Service Bulletin

Bulletin No.: 19-NA-174

Subject: Rear of Headliner Sagging, Rear Edge Visible Through Rear Window

Brand:	Model:	Model Year:		VIN:		Engine:	Transmission:
		from	to	from	to		
Chevrolet	Camaro (Coupe only)	2016	2019			All	All

5381469

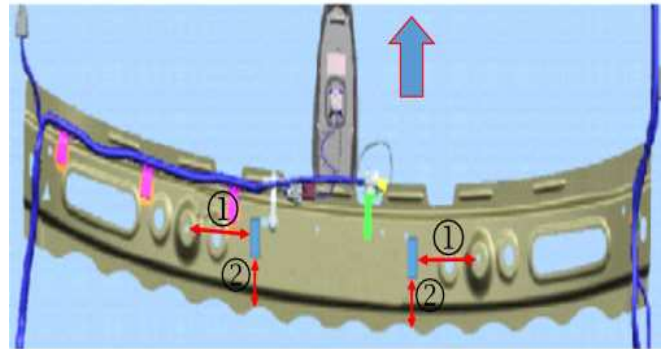
- 2.2. Position the tape edges at the locations dimensioned off of the rear crossmember in the graphic above. 153 mm (6.0 in) (1) inboard of the CENTER hole location and 51 mm (2.0 in) (2) from the rear edge of the crossmember.
